Amendment No. 33
License No. DPR-53

ATTACHMENT TO LICENSE AMENDMENT NO. 33

SAFETY EVALUATION BY THE OFFICE OF NUCLEAR REACTOR REGULATION
SUPPORTING AMENDMENT NO. 33 TO FACILITY OPERATING LICENSE NO. DPR-53

BALTIMORE GAS AND ELECTRIC COMPANY
CALVERT CLIFFS NUCLEAR POWER PLANT, UNIT NO. 1

FIGURE 3.2-2
 Linear Heat Rate
 Axial Flux Offset Control Limits

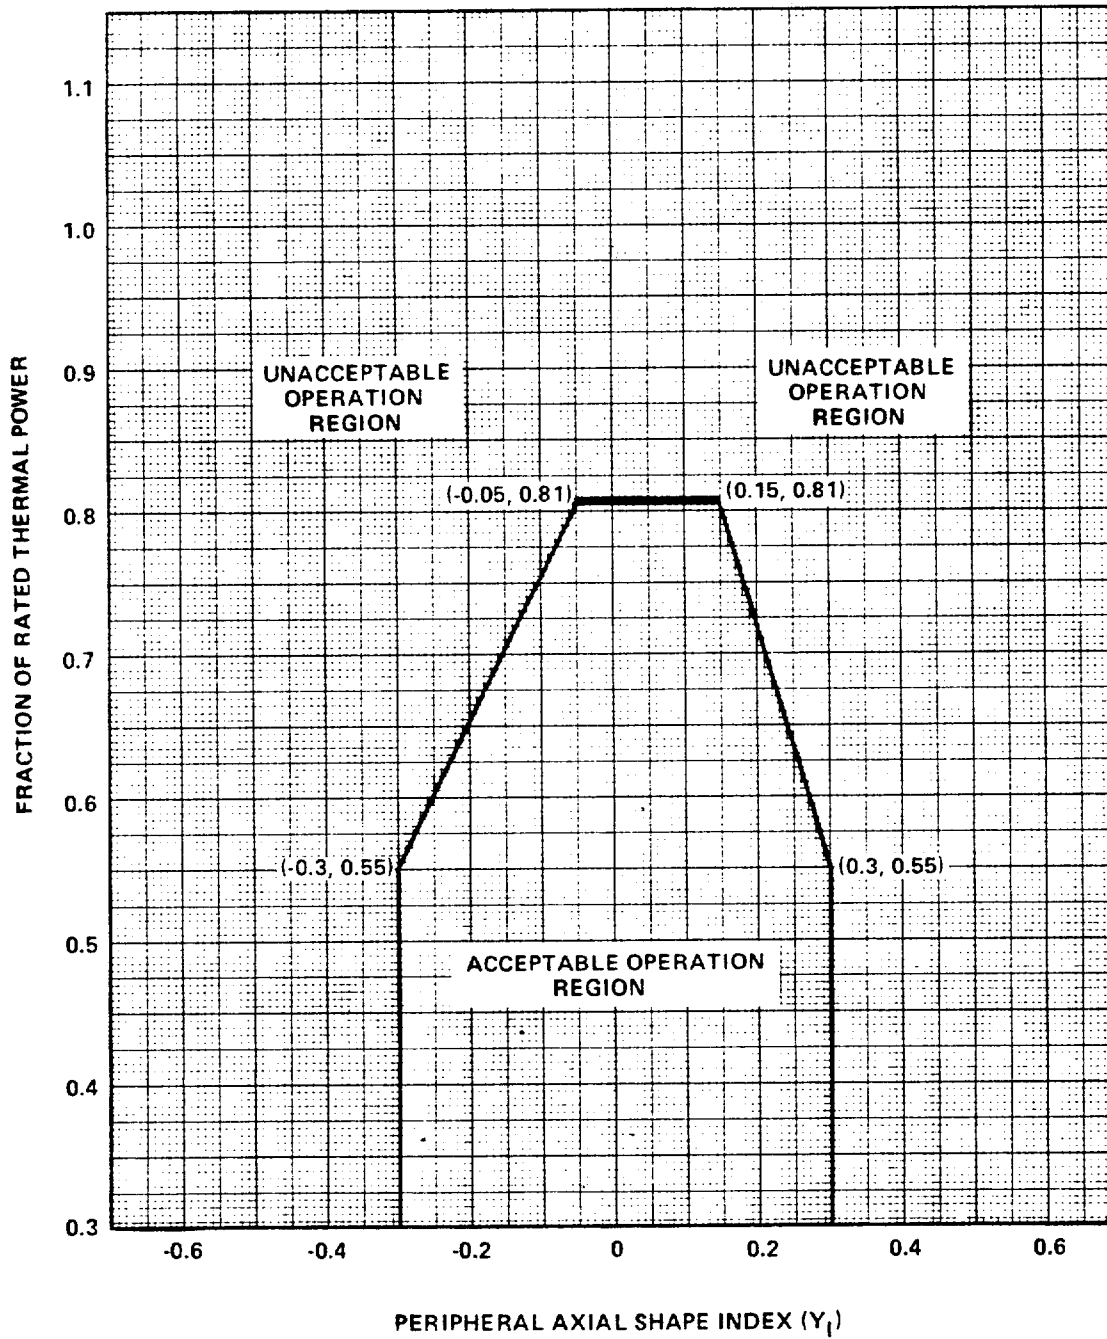
The LHR ASI Control Limit Tent for the Cycle 3 NSA (proposed TS Figure 3.2-2) was constructed to be consistent with the changes proposed in sections 3.1.2, 3.1.4, 3.2.2 and 3.2.4.

FIGURE 3.2-3

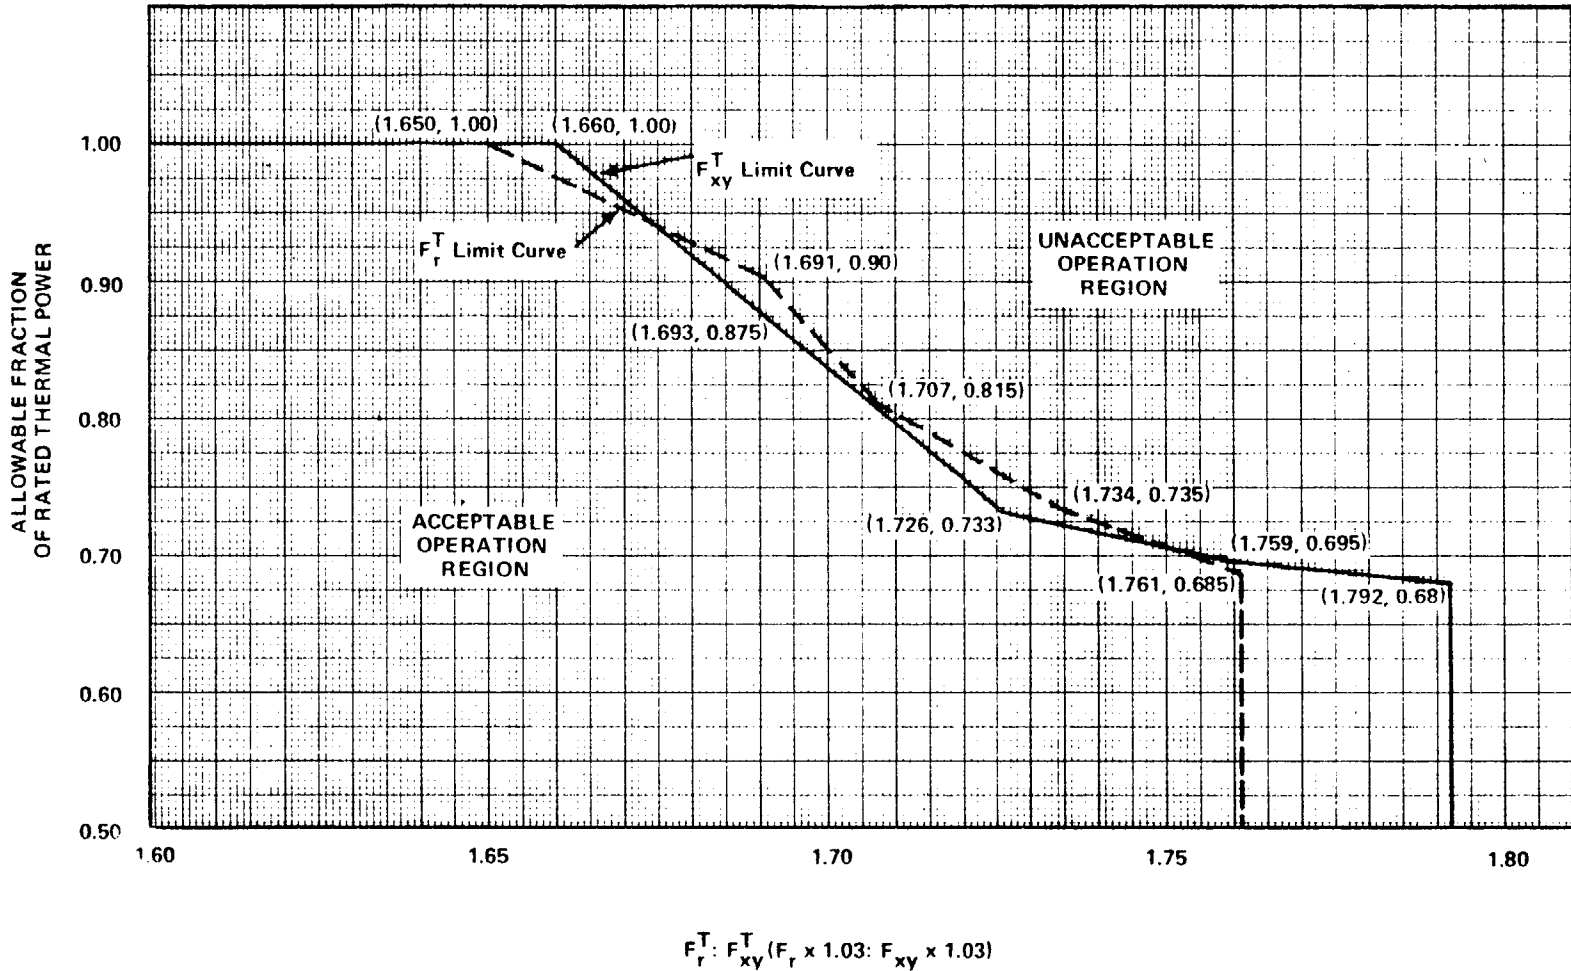
The allowed ASI power level control limit as a function of F_r^T (TS Figure 3.2-3) would change to allow larger values of F_r^T . In particular, for 100% power, the allowed value of F_r^T would be increased from 1.48 for the OSA to 1.65 for the NSA. This change would accommodate the fact that Cycle 3 experience has demonstrated that 1.65 is the lowest F_r^T that is achievable during steady state operation at or near the beginning of the cycle. Since this operating change was incorporated in the NSA, it is acceptable.

The allowed ASI power level alarm limit as a function of F_{xy}^T (TS Figure 3.2-3) would change to allow larger values of F_{xy}^T . In particular, for 100% power the allowed value of F_{xy}^T would be increased from 1.54 for the OSA for Cycle 3 operation to 1.66 for the NSA for Cycle 3 operation. This change would accommodate the fact that Cycle 3 experience has demonstrated that 1.66 is the lowest F_{xy}^T that is achievable during steady state operation at or near the beginning of the cycle. Since this change was incorporated in the new analysis, it is acceptable.

FIGURE 3.2-4
DNB Axial Flux Offset Control Limits

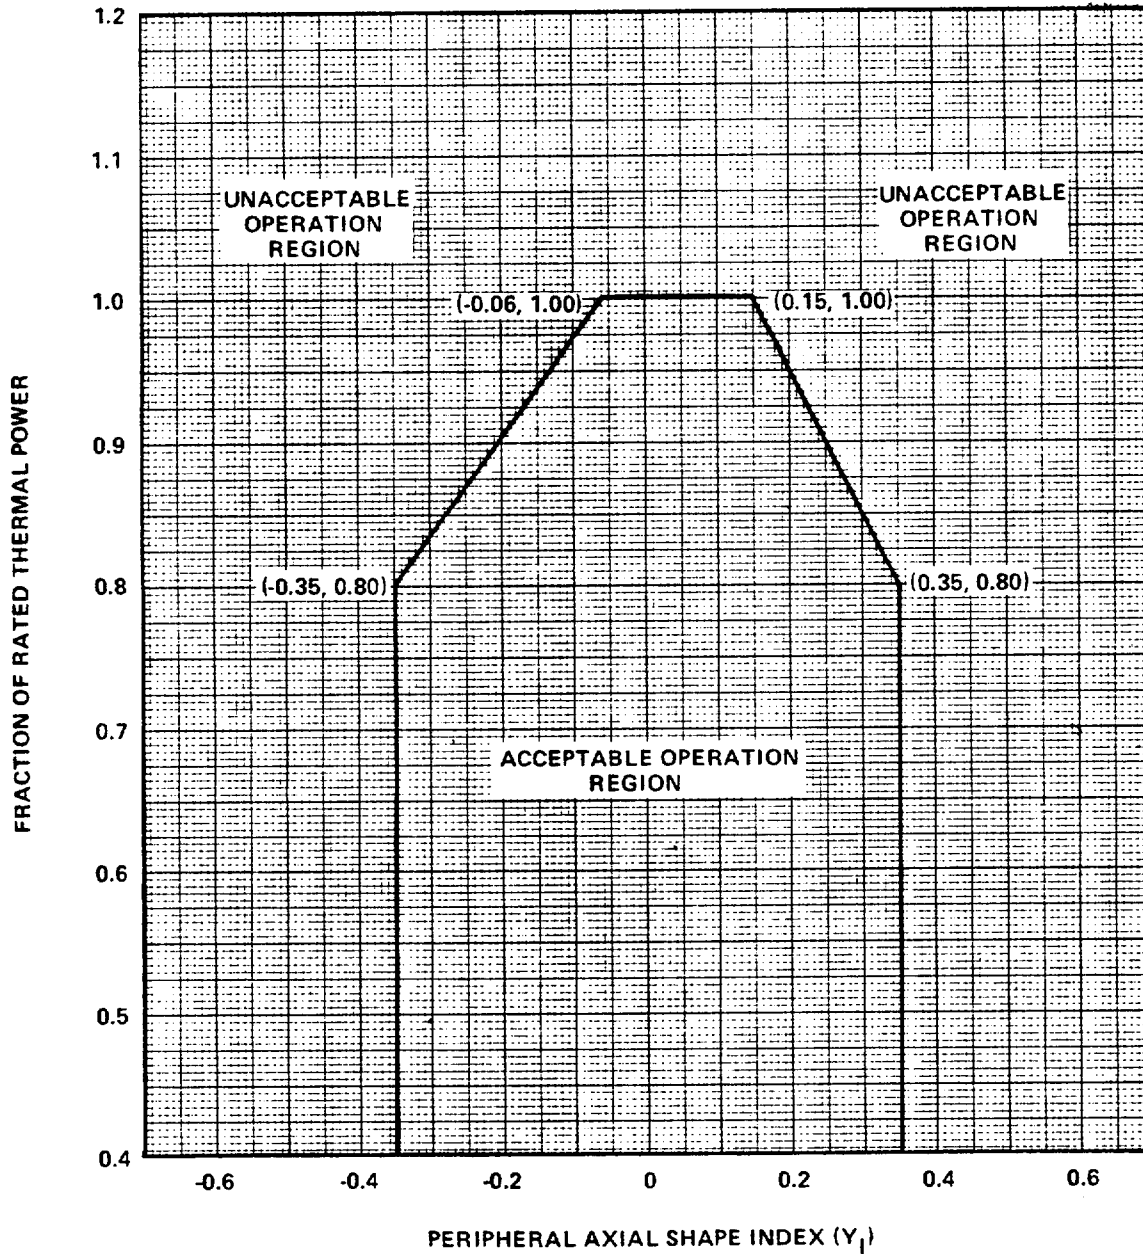
The DNB ASI Control Limit Tent for the new Cycle 3 analysis (proposed TS Figure 3.2-4) was constructed to be consistent with the changes indicated in sections 3.1.1, 3.1.3, 3.2.1, 3.2.2, and 3.2.3.
